September 15, 2017

RE: Starbucks at Academy Gateway (PPR-17-030) Review 2

MERIDIAN, EL PASO COUNTY, COLORADO
MAJOR SITE DEVELOPMENT PLAN

SHEET TITLE:
COVER SHEET

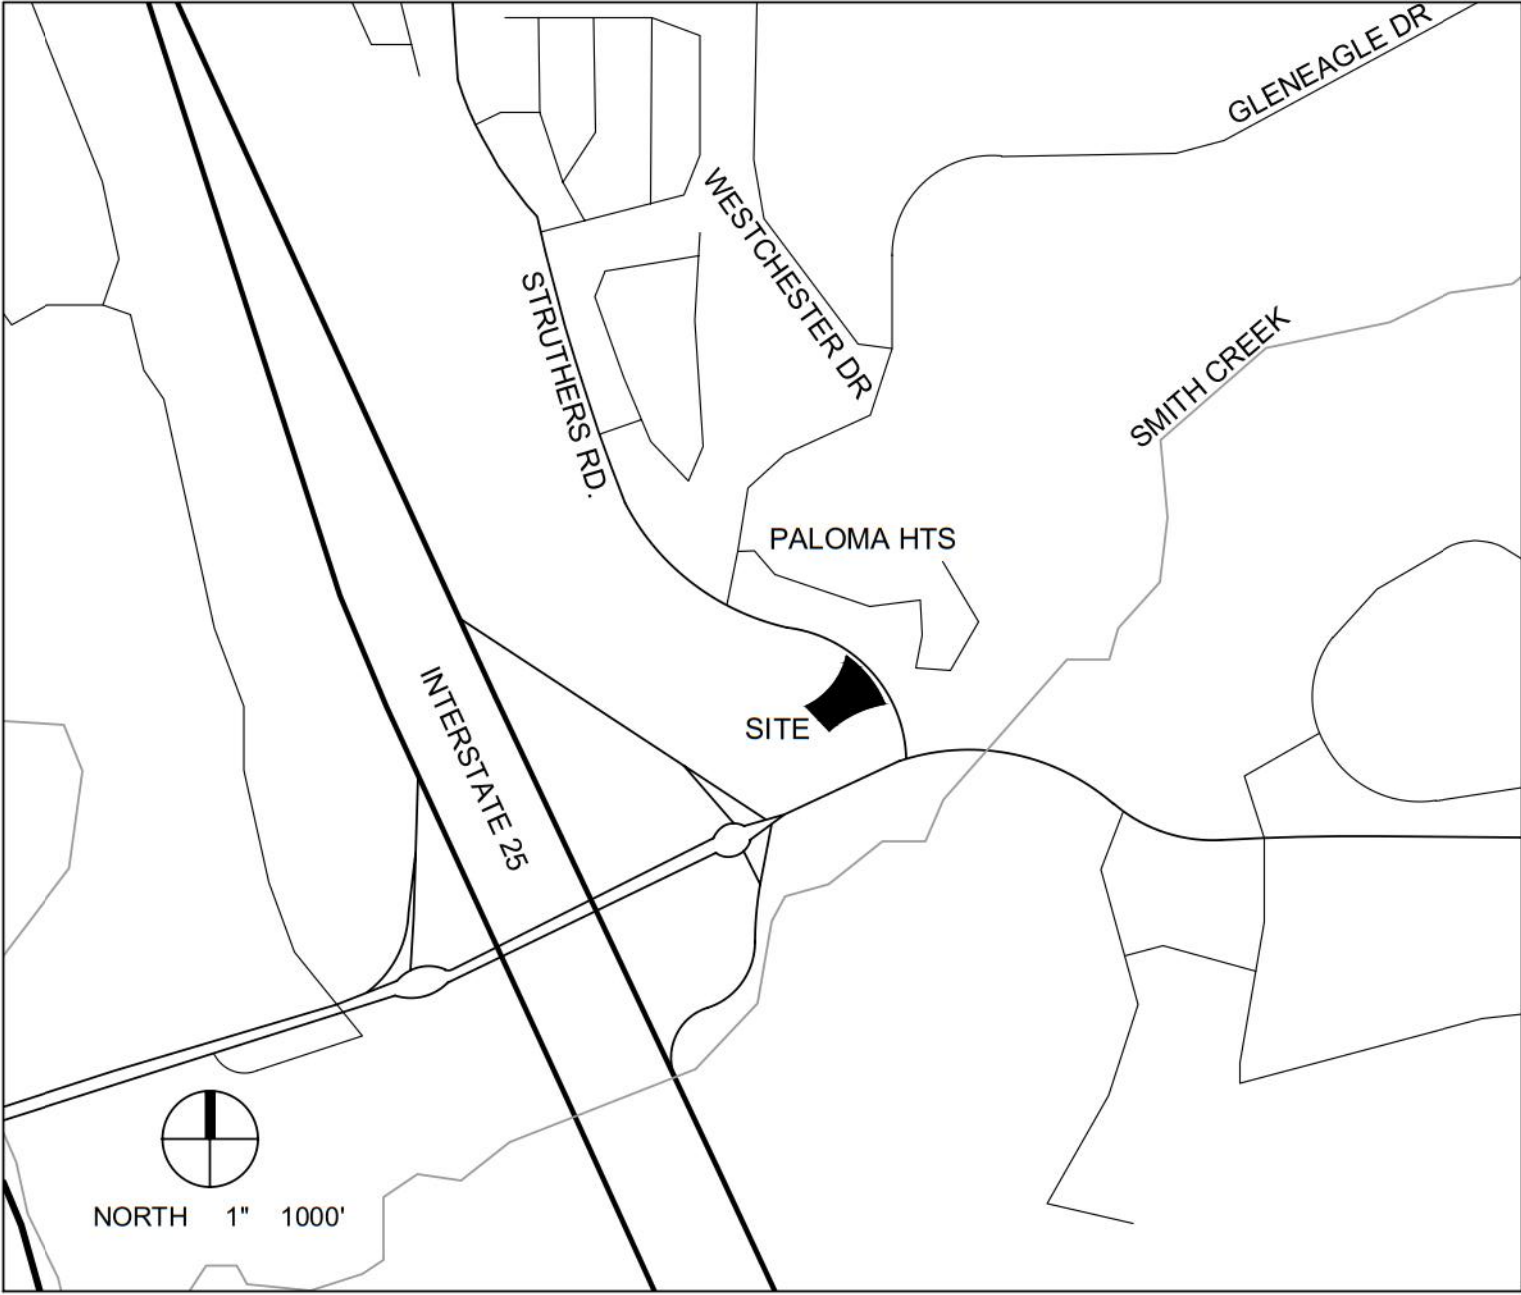
Sidewalk should extend to the edge of the property. Show the PED ramps. The improvement on your property and it is required with development of this property

Provide fence locations as shown in details

SITE PLAN

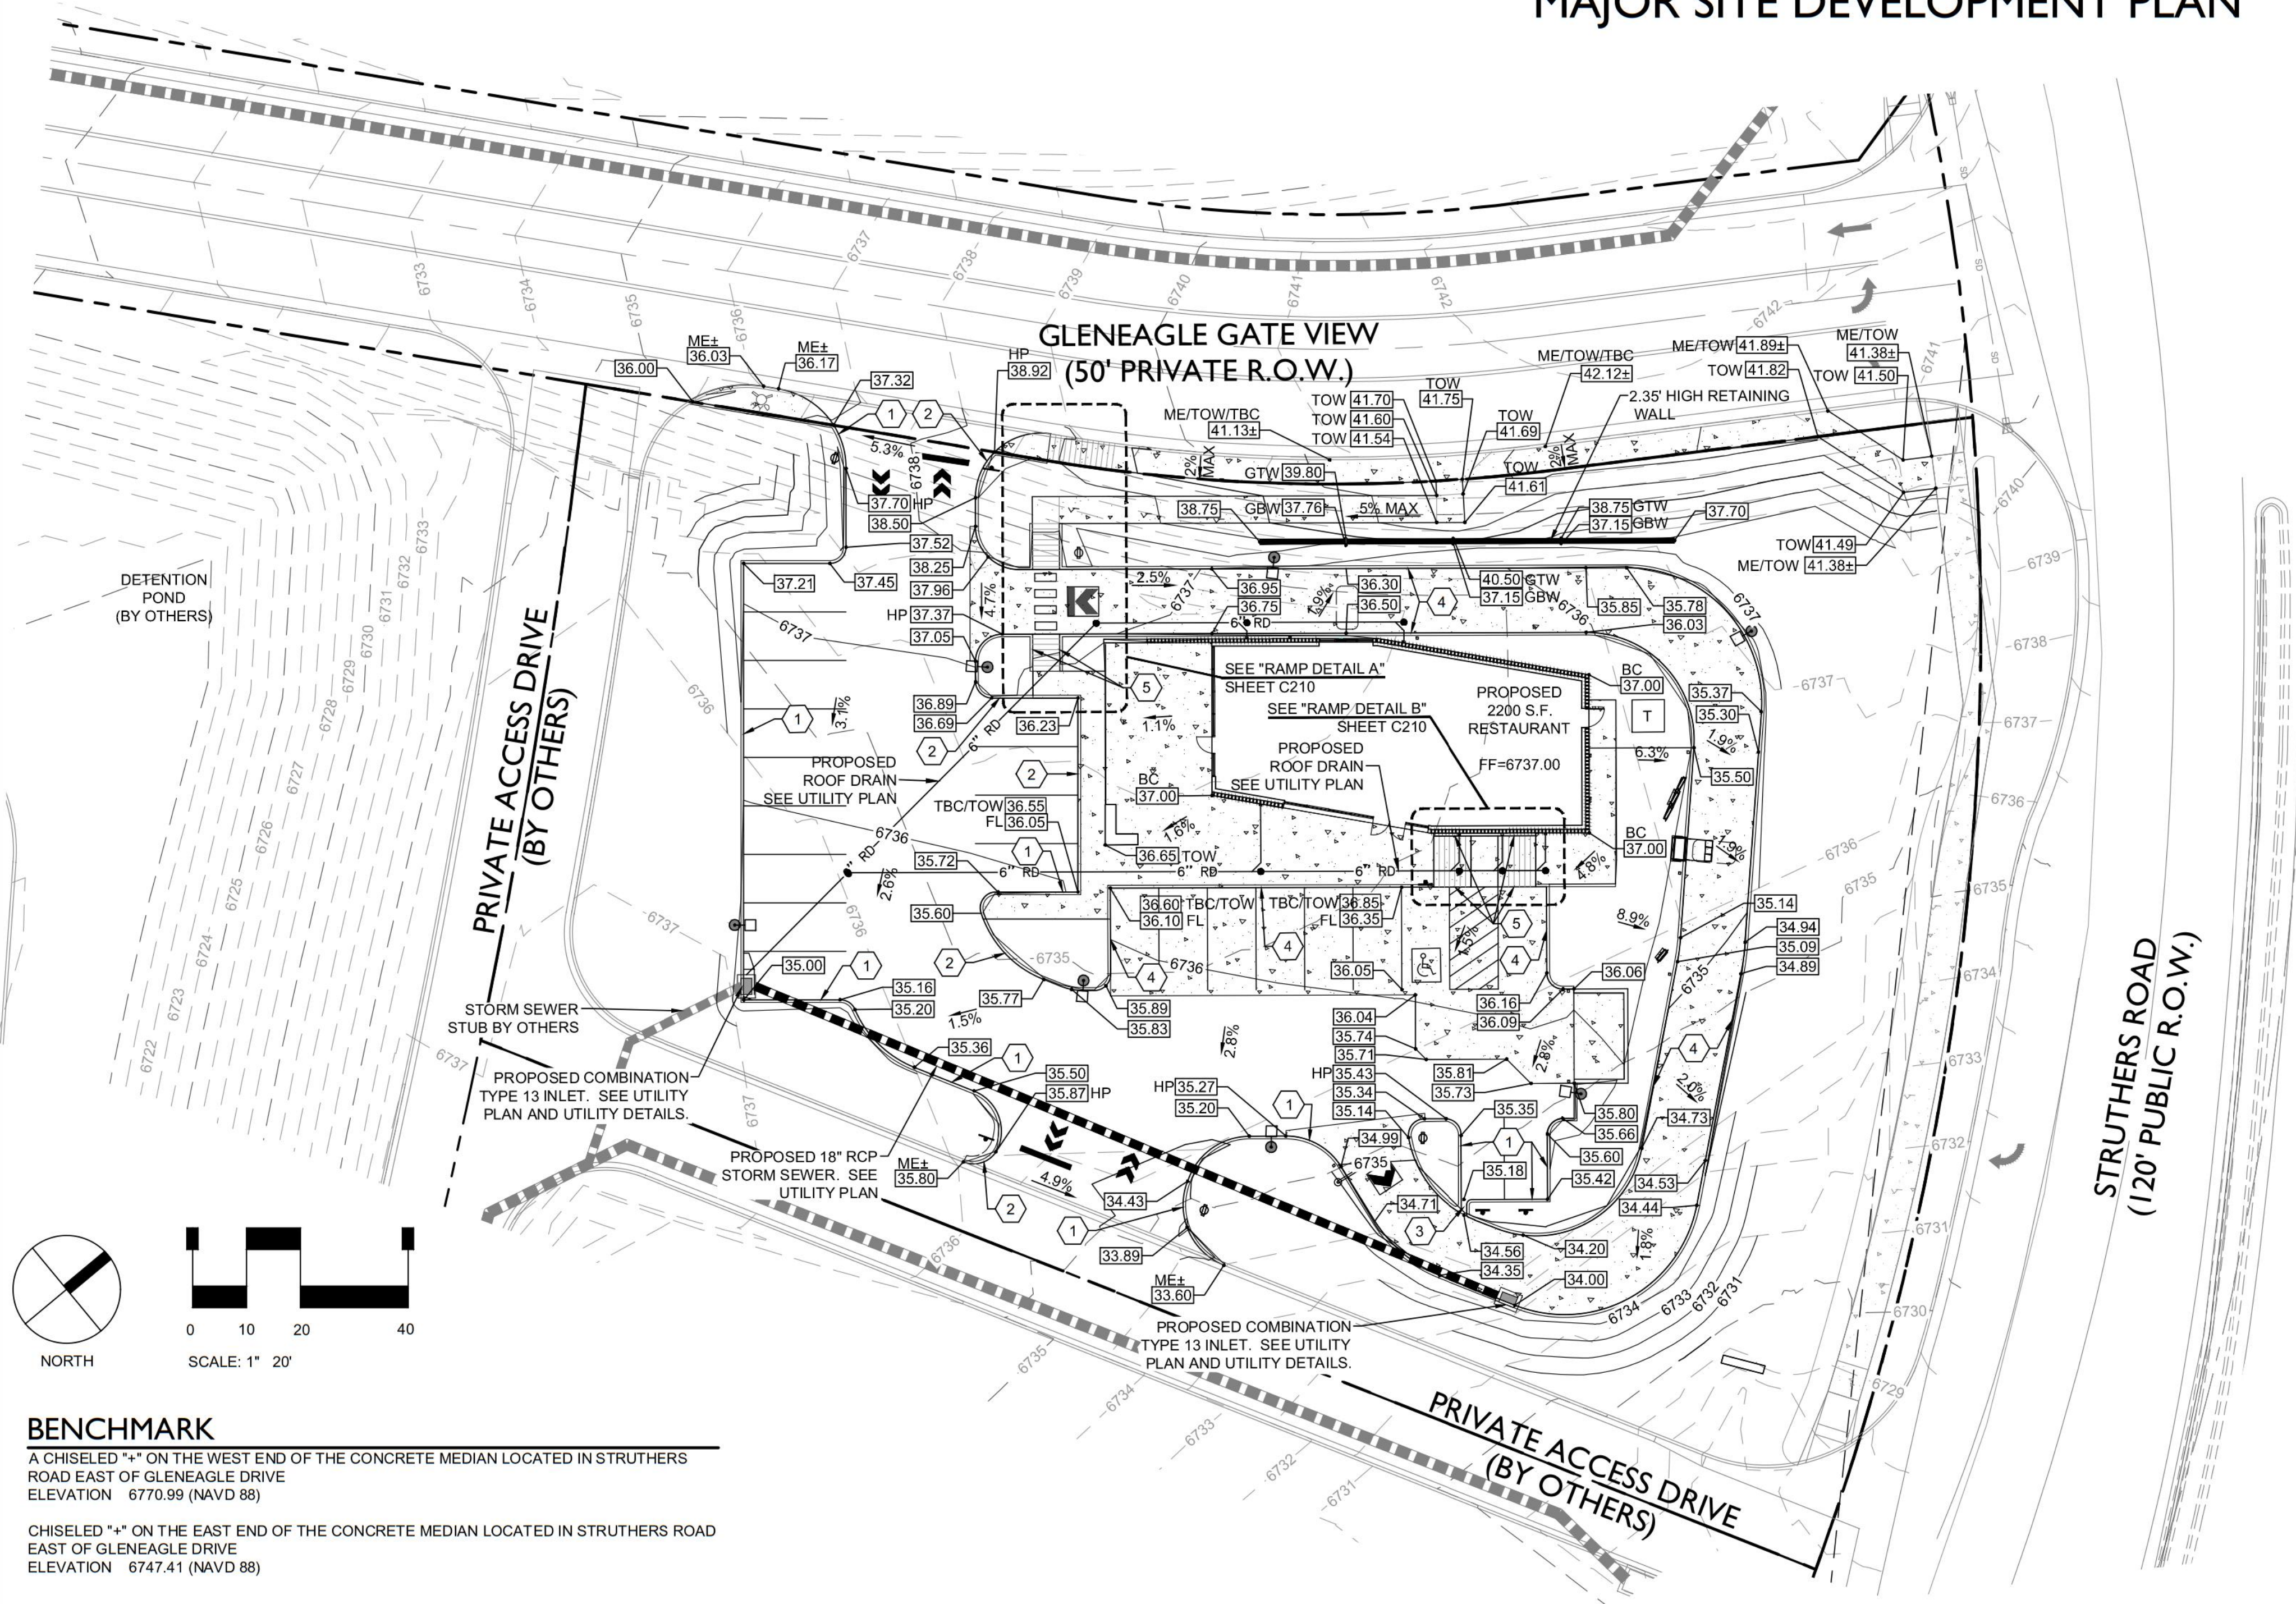
2 feet of overhang is required with an 8' x 15' space. A transformer is shown here; that may be a safety concern. Remove parking space.

A line has been added to the Site and Landscape plans showing 2' clear. The transformer is located behind the building.

DUMPSTER ENCLOSURE - WEST ELEVATION

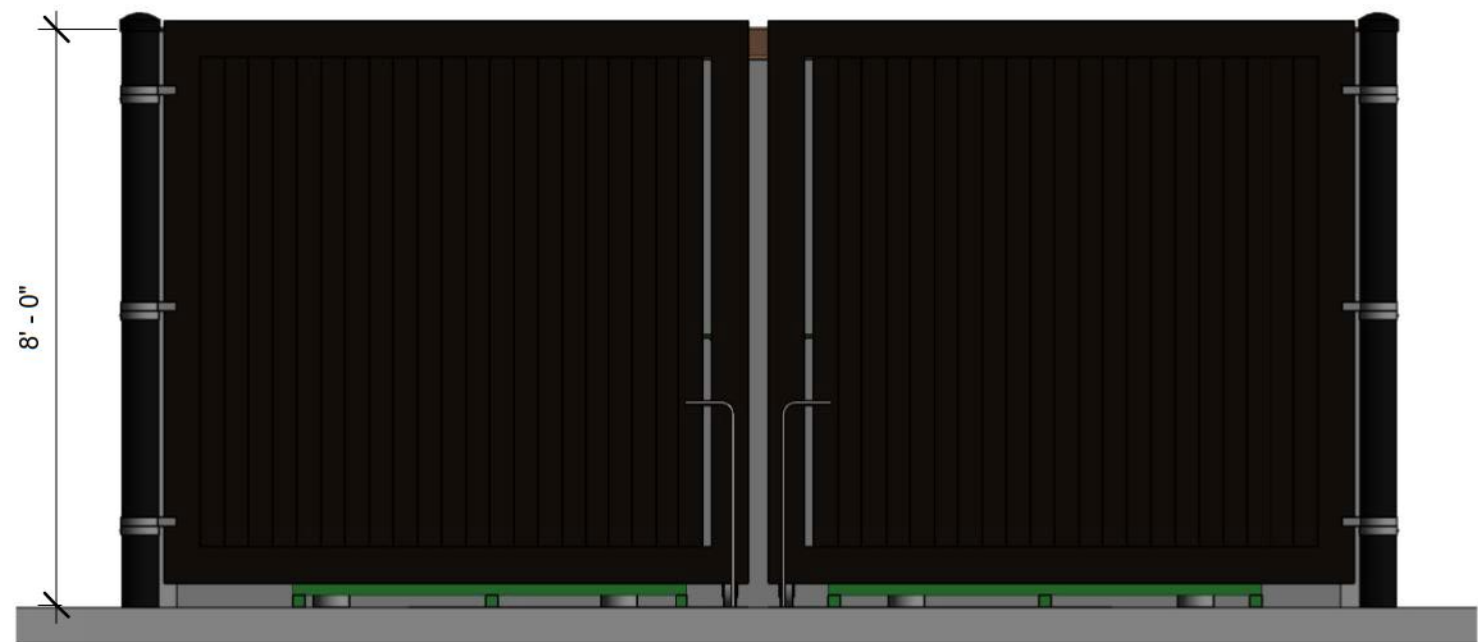
mesh is not 100% opaque please revise material to stucco, CMU, decorative concrete, etc....

Elevations have been updated with callouts to reflect materials. No portion of the trash enclosure is open, all is 100% opaque as required.
